## FirstNet RFP Summary

### Executive Summary

*Figure 1: User Density for Minnesota and Alabama*

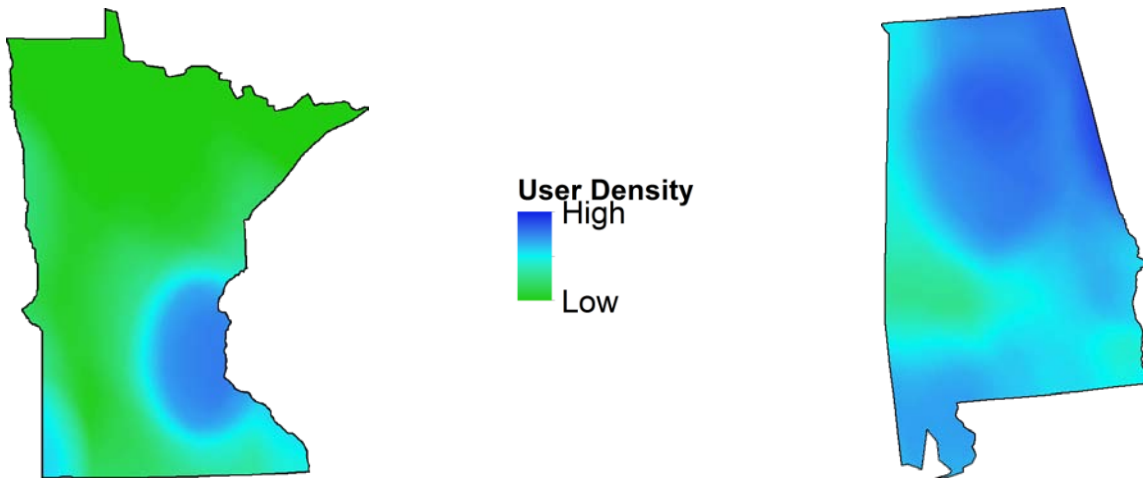
- The RFP only says Offeror should use “appropriate” losses; it does not specify what they are
- User Density heat maps seem to have a questionable methodology; e.g. Minnesota vs. Alabama

- The methodology for preparing these heat maps over-represents rural areas in some states while under-representing small and medium-sized cities in others

- According to the user density map, Alabama is almost entirely urban while Minnesota is almost entirely rural. In reality, both states are mostly rural

- Note, Alabama has five small/medium-sized metropolitan areas scattered throughout the state, while Minnesota has only one major metropolitan center (the Twin Cities) and some smaller metropolitan areas (e.g., Rochester, Duluth)

- Note, missing population centers not represented include:

- Rochester, St Cloud and the Saint Cloud to Morehead Corridor, Bemidji, Mankato
- Note, there is a puzzling increase in Rock and Pipestone Counties; likely a spill-over from Sioux Falls
- Methodology appears to include only cities of population greater than 150,000

Figure 2: FirstNet Coverage Objective from RFP<sup>4</sup>

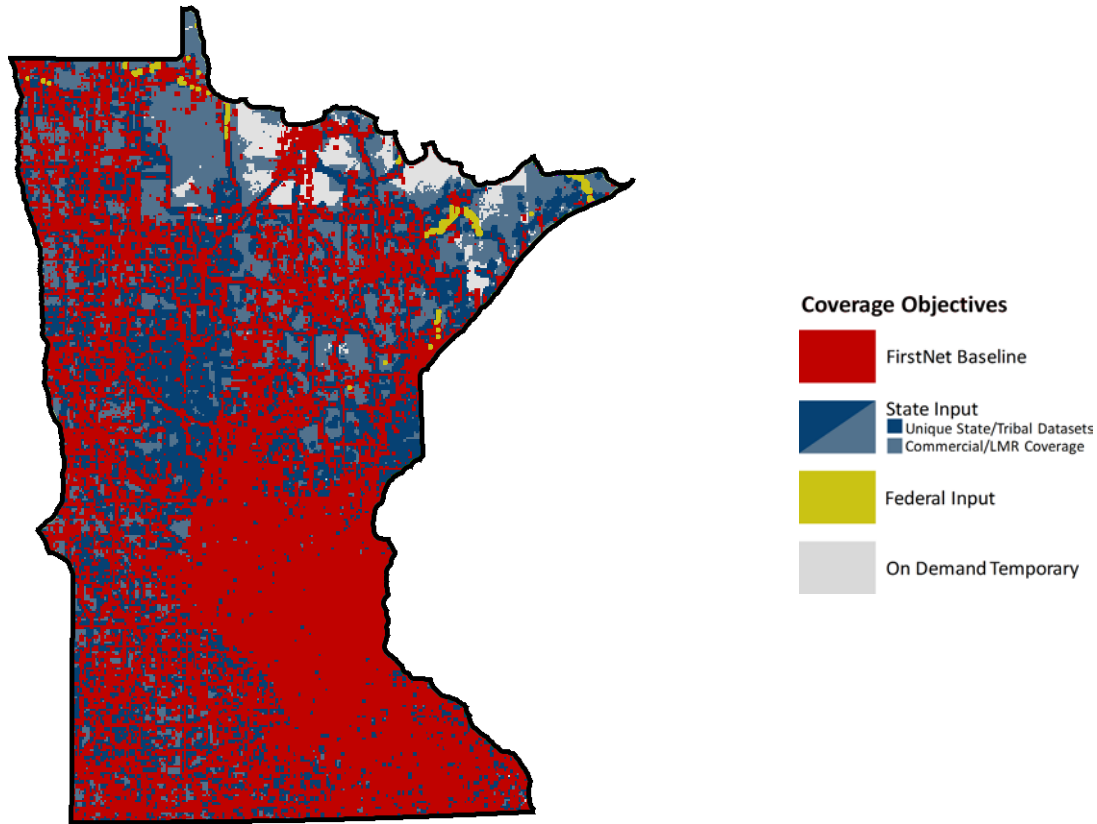
- FirstNet’s coverage objective for Minnesota designates about 97% of the state as a target for persistent terrestrial coverage.

- This objective differs greatly from FirstNet’s original coverage objective. Its draft RFP differs in the following ways:
  - It includes state input as (1) “unique data” and (2) existing commercial/LMR coverage.
    - “Unique data” layer represents the Phase 4 coverage requirement.
  - It includes a small amount of federal input.
  - It has the same FirstNet baseline as presented in the 2015 draft RFP; however, there is no gradation and the entire FirstNet baseline is one color. It *appears* like a larger area.

- FirstNet applied Minnesota’s submitted coverage requirements from September 2015 to its “coverage objectives” without change. However, they are included as an “objective” and not a “requirement”.
  - Aside from very remote areas (e.g., Superior National Forest, Boundary Waters Canoe Area Wilderness, and Voyageurs National Park), all of the state is considered a “coverage objective”.
  - There is no reference to the State’s phased approach within the RFP; the State’s phased objectives are found only in the “reading room”.
- Note; the RFP states vendors will be evaluated on a state-by-state basis on how well they meet this objective. However, the RFP does not state *how* vendor coverage will be evaluated—just that it will be.

Figure 5: Urban-Rural Area in FirstNet RFP

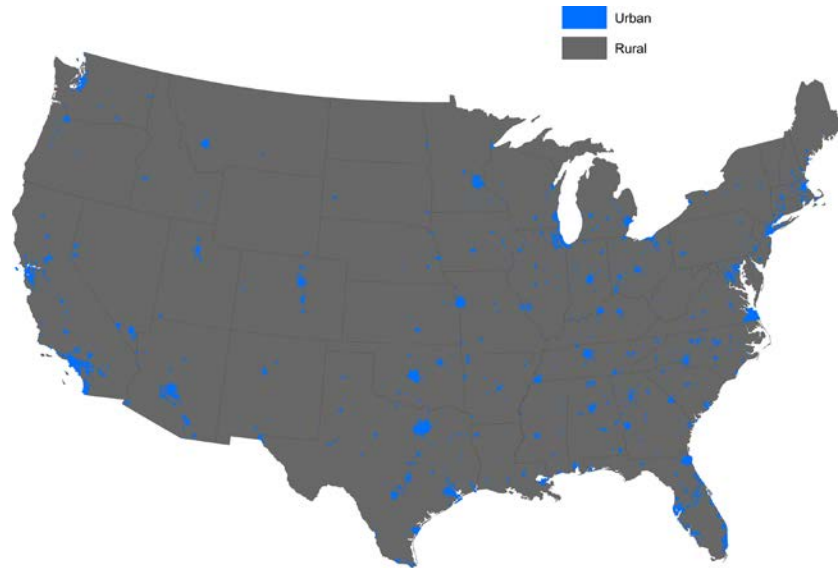
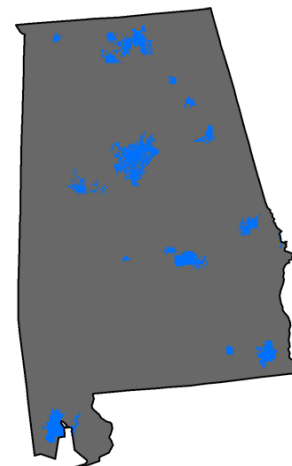
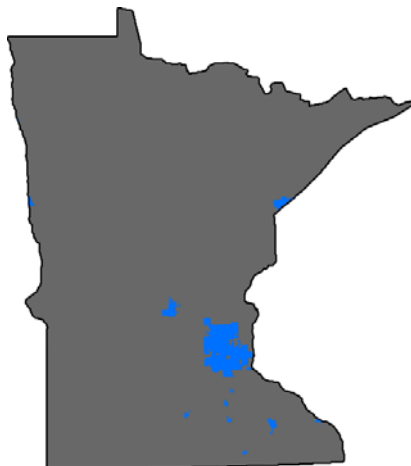
- Almost all of the country is considered “rural”: 97.48%.

- For comparison; Minnesota and Alabama:
  - Minnesota is 1.91% urban; population 5.46 million; density 68.9 pops/sq. mi
    - Largest urban area: Twin Cities, 3.459 million
  - Alabama is 4.53% urban; population 4.84 million; density 95.4 pops/sq. mi
    - Largest urban area: Birmingham, 1.304 million
